Staff Summary Report

Development Review Commission Date: 08/14/12

SUBJECT: Hold a public meeting for a Development Plan Review for MAIN EVENT ENTERTAINMENT, located at 8545 S. Emerald Drive.

DOCUMENT NAME: DRCr_MainEvent_081412 PLANNED DEVELOPMENT (0406)

CONCEPTUAL SITE PLAN FOR MAIN EVENT ENTERTAINMENT
8545 S. EMERALD DRIVE
TEMPE, ARIZONA

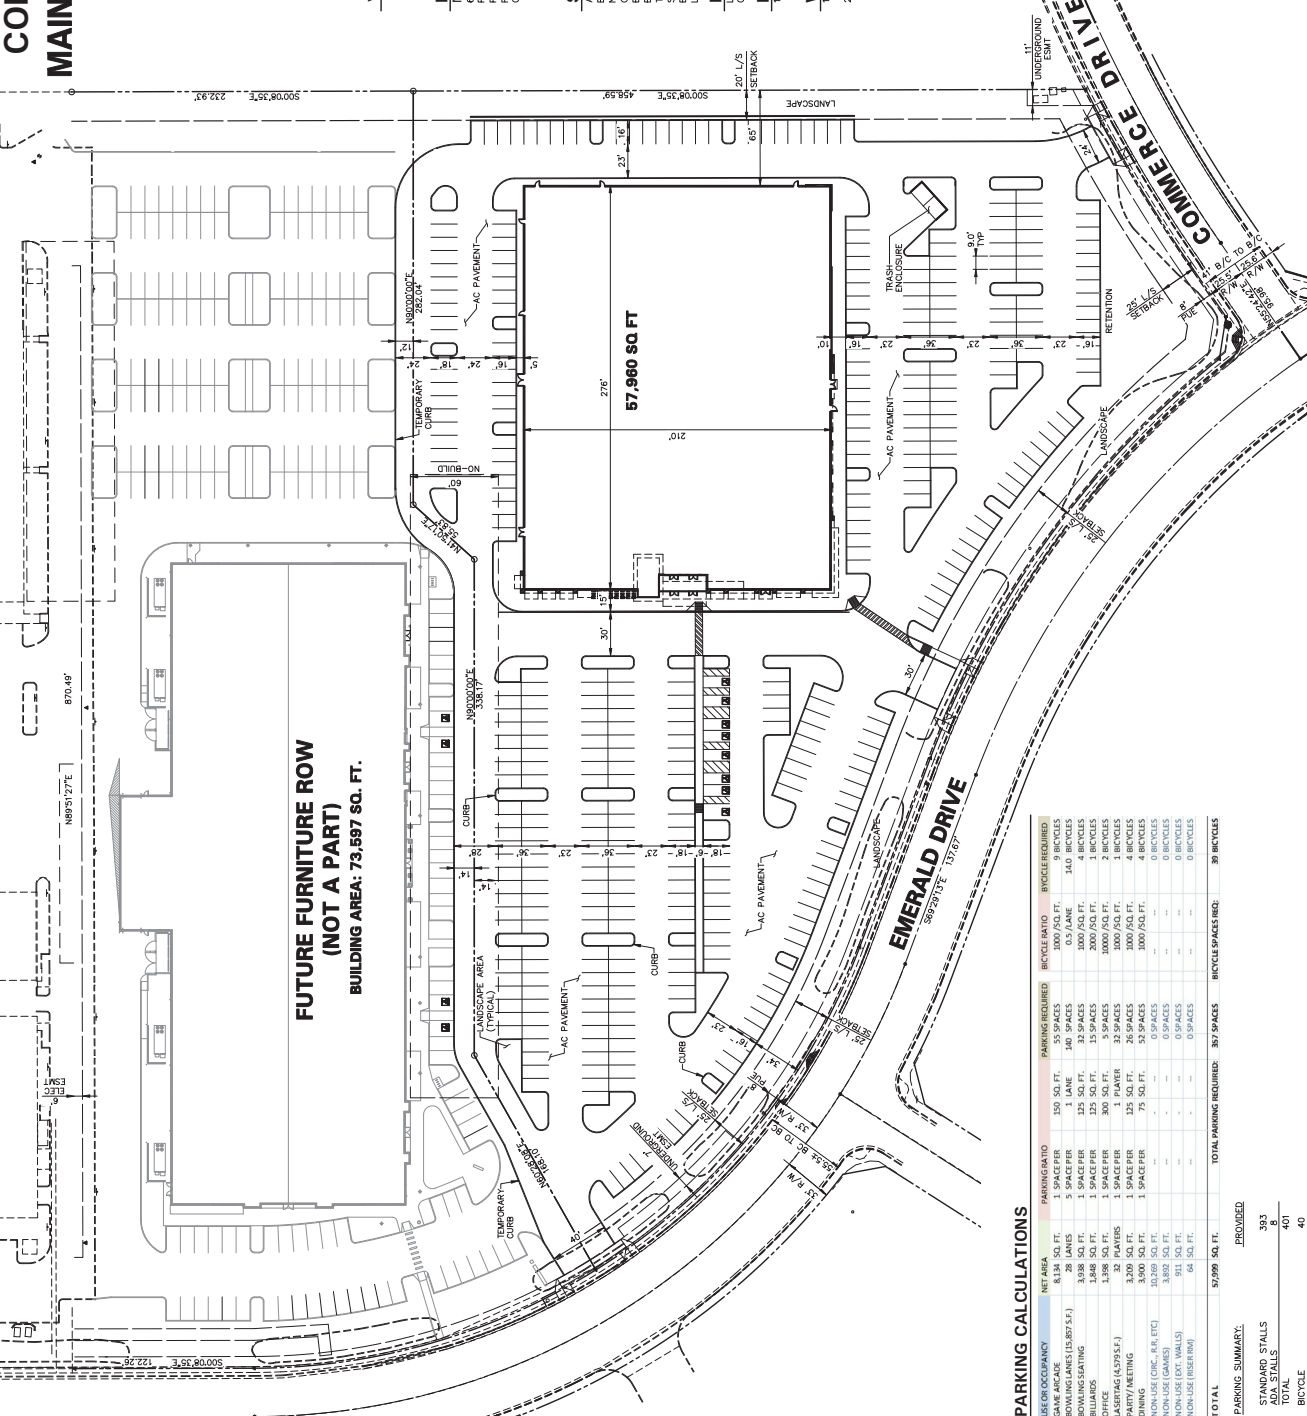
1. Provide a shared parking model and recorded agreement between this property and the property to the north (future Furniture Row site).

2. Provide 8'-0" wide public sidewalk along arterial roadways, or as required by Traffic Engineering Design Criteria and Standard Details.
3. If service yards are needed, provide yard walls that are at least 8'-0" tall as measured from adjacent grade and are at least the height of the equipment being enclosed, whichever is greater.

4. Verify height of ground and roof mounted equipment and mounting bases to ensure that wall or parapet heights are adequate to fully screen the equipment on all four sides. Locate electrical service entrance sections (SES) inside the building or inside a service yard.

5. Refuse gates shall be steel vertical picket, steel mesh, steel panel or similar construction. Where a gate has a screen function and is completely opaque, provide vision portals for visual surveillance. Provide gates of height that match that of the adjacent enclosure walls. Review gate hardware with Building Safety and Fire staff and design gate to resolve lock and emergency ingress/egress features that may be required.

6. Provide upgraded paving at each driveway consisting of unit paving. Extend this paving in the driveway from the right-of-way line to 20'-0" on site and from curb to curb at the drive edges. From sidewalk to right-of-way line, extend concrete paving to match sidewalk.

9. Provide 16' deep parking stalls with 2' of overhang within the landscape area, increasing the size of the parking lot islands to accommodate this overhang and reduce paving area, without conflict between vehicle bumpers.

10. Do not use parking tire stops in parking spaces; where raised walkway is provided in center parking row, utilize 16' deep stalls with 2' of overhang, creating a 10' wide concrete path in the center.

11. Provide raised speed table in front entrance drive from the center parking row to main entrance where sidewalk has been provided.

01 SCHEMATIC ELEVATION STUDY WEST ELEVATION

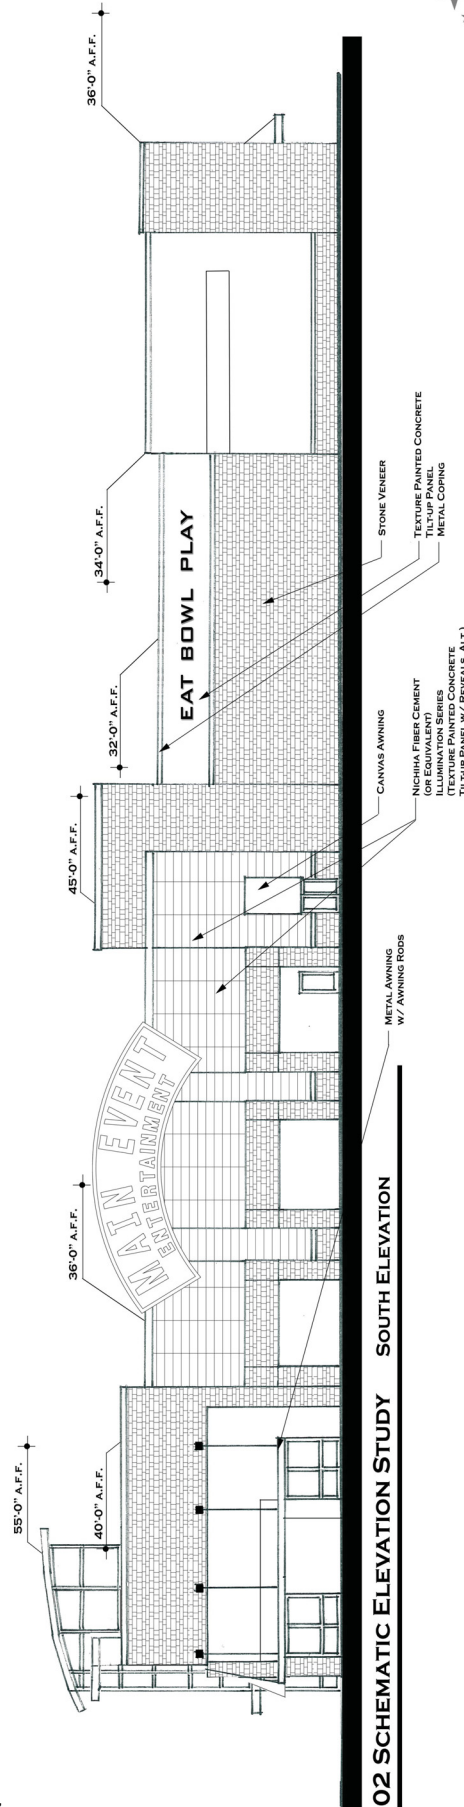
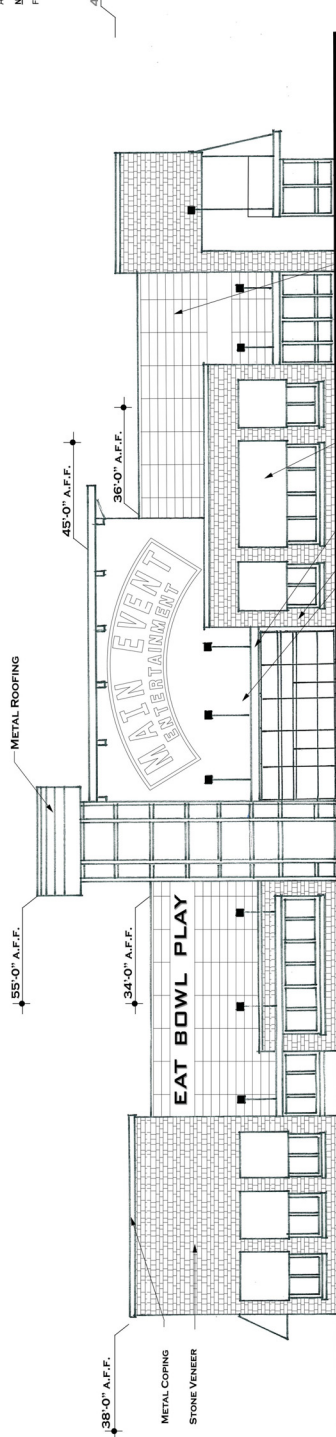
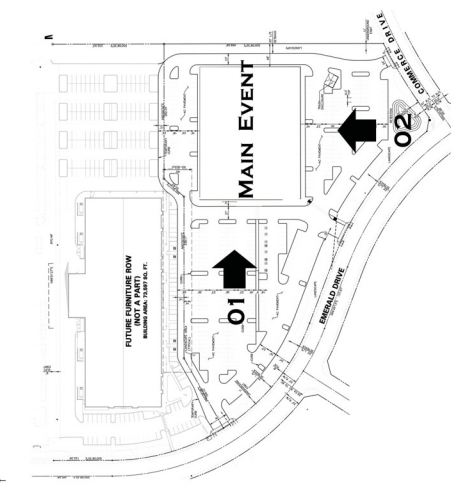
14. The materials and colors are approved as presented:

Provide main colors and materials with a light reflectance value of 75 percent or less. Specific colors and materials exhibited on the materials sample board are approved by planning staff. Additions or modifications may be submitted for review during building plan check process.

15. Provide secure roof access from the interior of the building. Do not expose roof access to public view.

16. Conceal roof drainage system within the interior of the building.

17. Incorporate lighting, address signs, and incidental equipment attachments (alarm klaxons, security cameras, etc.) where exposed into the design of the building elevations. Exposed conduit, piping, or related materials is not permitted.

18. Upper/lower divided glazing panels in exterior windows at grade level, where lower glass panes are part of a divided pane glass curtain-wall system, shall be permitted only if laminated glazing at these locations is provided.
